MIL-P-63225A (AR)
AMENDMENT 4
28 MARCH 1990
SUPERSEDING
AMENDMENT 3
12 July 1989

MILITARY SPECIFICATION

PROJECTILE, GUIDED, 155MM, M712
CONTROL SECTION FOR

FIGURE 1.
Closed Loop Position Gain Limits
*(Command Voltage, Feedback Voltage)

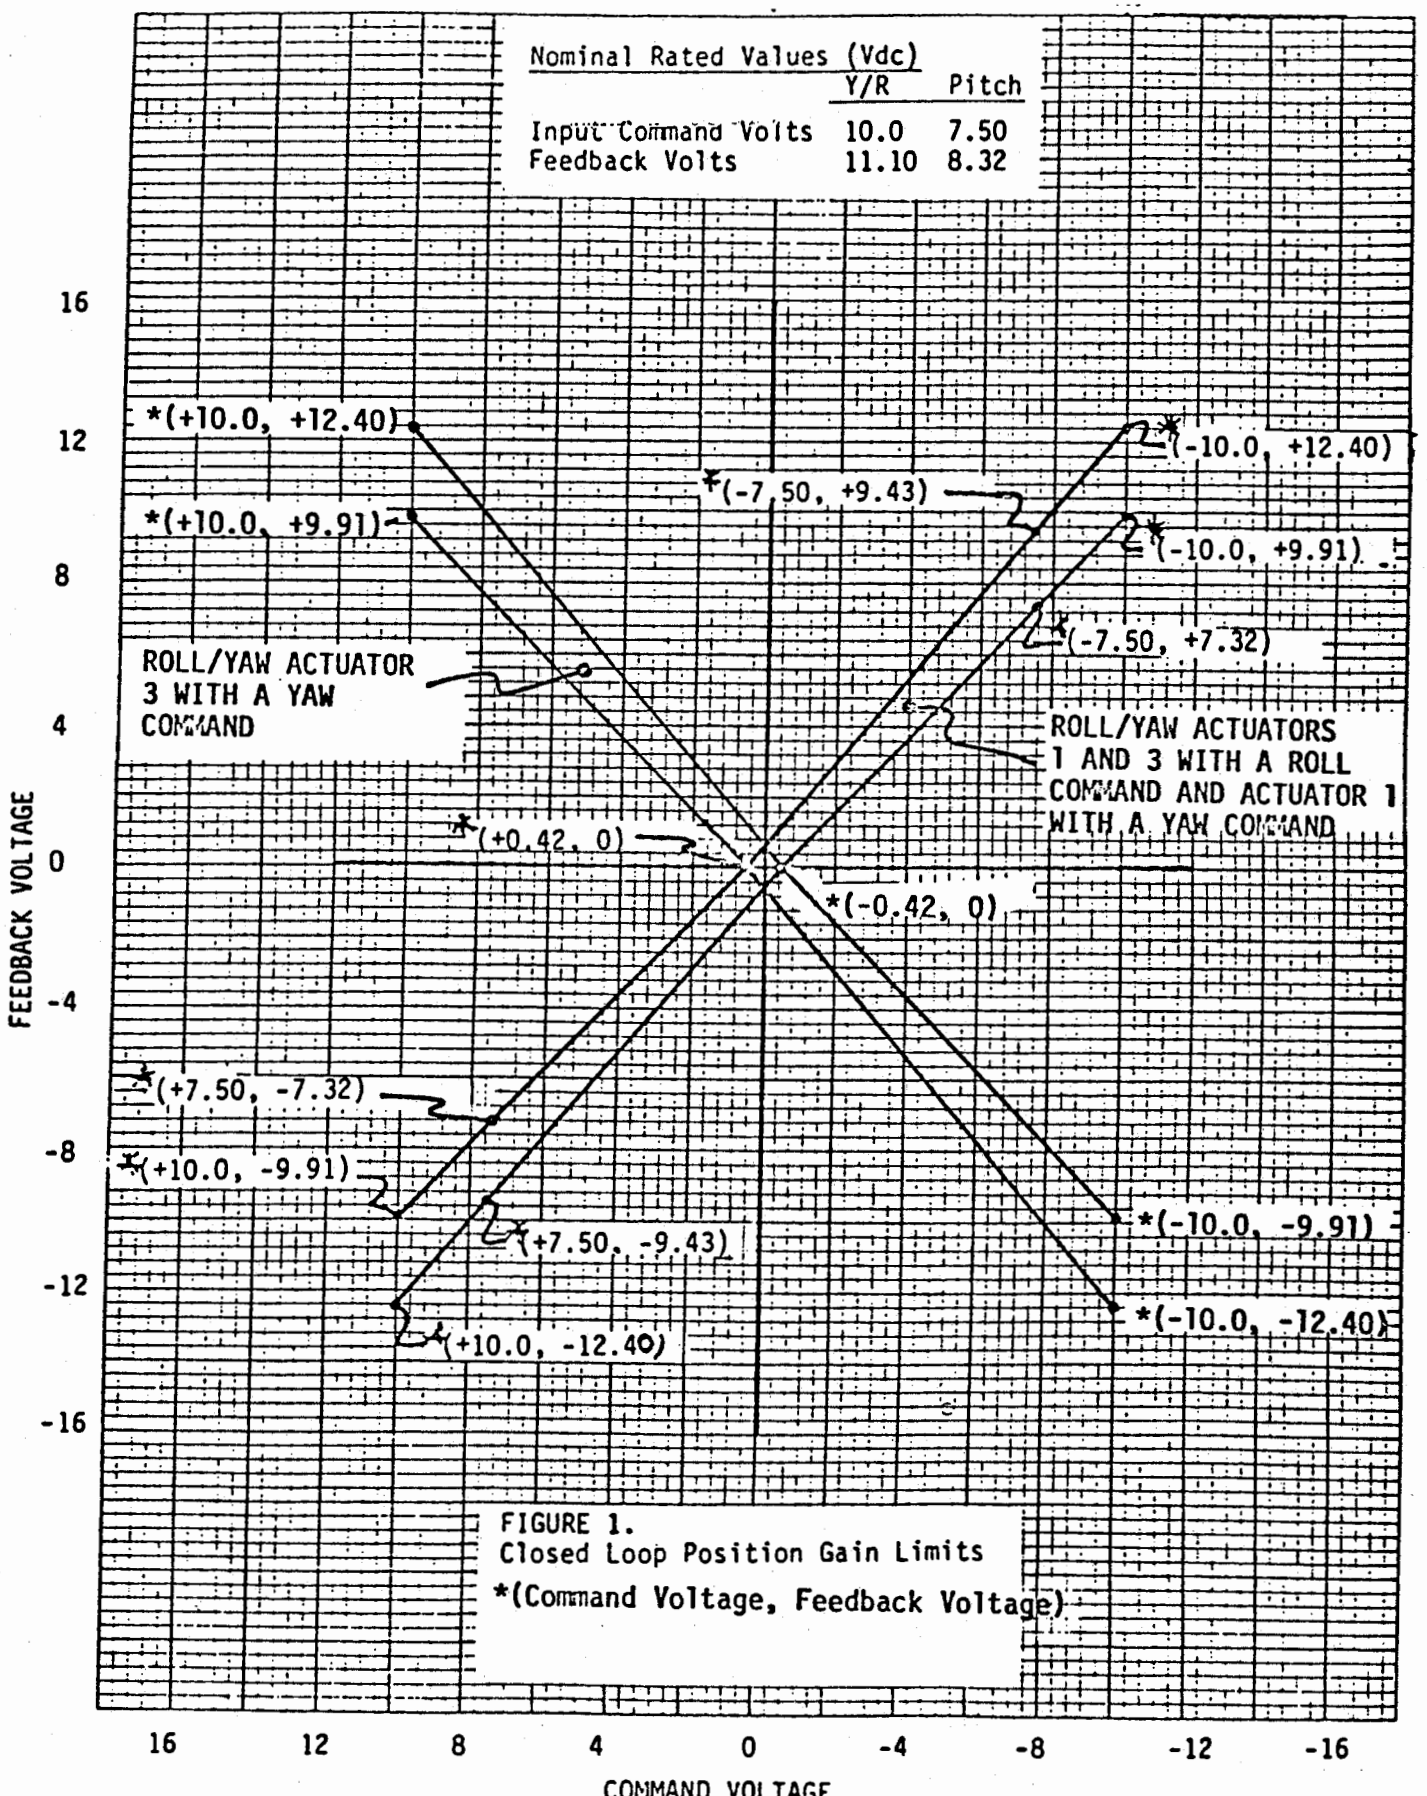
* Delete Figure 1 in its entirety and substitute the included Figure 1.

FIGURE 6

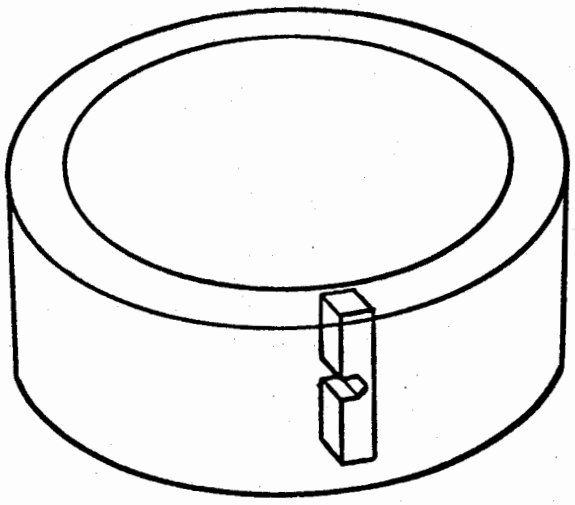
3.3.4.1 Ultrasonic examination. The weld zone shall be ultrasonically inspected using an angle beam method. No discontinuity shall be acceptable which is more than 1DB below that obtained from the least responsive notch in the reference standard per Figure 6.

4.5.14.2 Ultrasonic inspection standards. Reference standards shall be of the same thickness, material and configuration as the parts being examined. Simulated discontinuities will be circular segment notches circumferentially cut into the I.D. and O.D. of each weld zone. See Figure 6. For each weld zone I.D. and O.D. there will be 3 notches. One at the near side of the weld zone, one at the nominal center of the weld zone, and one in the far side of the weld zone. The reference standard shall be appropriately treated to inhibit corrosion."

1. NOTCH CROSS SECTIONAL AREA 0.00174 SQ. IN.
2. I.D. NOTCH HAS SAME DIMENSIONS AS SHOWN ABOVE

FIGURE 7

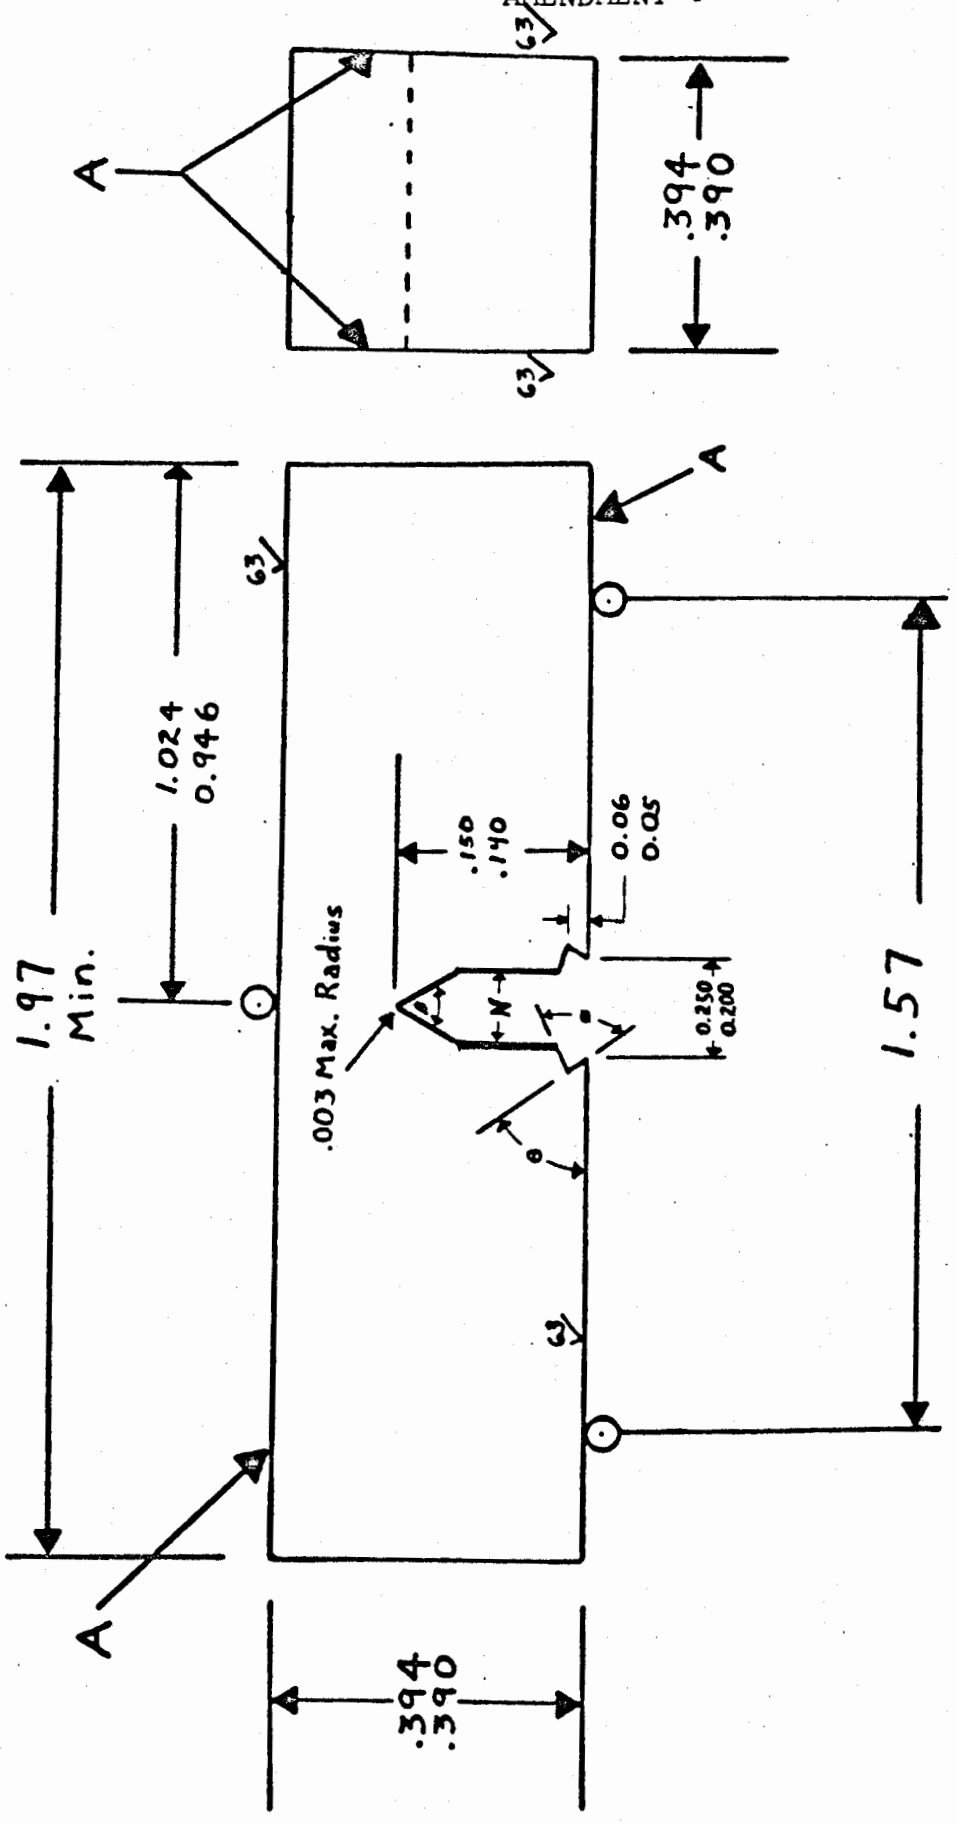
4.5.15.2 Fracture toughness specimen selection. Three (3) specimens shall be taken from the housing that exhibited the high ultimate strength readings (above 280 Kpsi). If both housings exhibit high ultimate strength readings then the housing with the highest hardness reading shall be used for specimen selection. The three specimens shall be selected in the longitudinal direction and taken from the aft end of the housing. The specimen shall have a crack plane orientation L-C as shown in Figure 7. The specimen dimensions shall be within the tolerances shown in Figure 9.
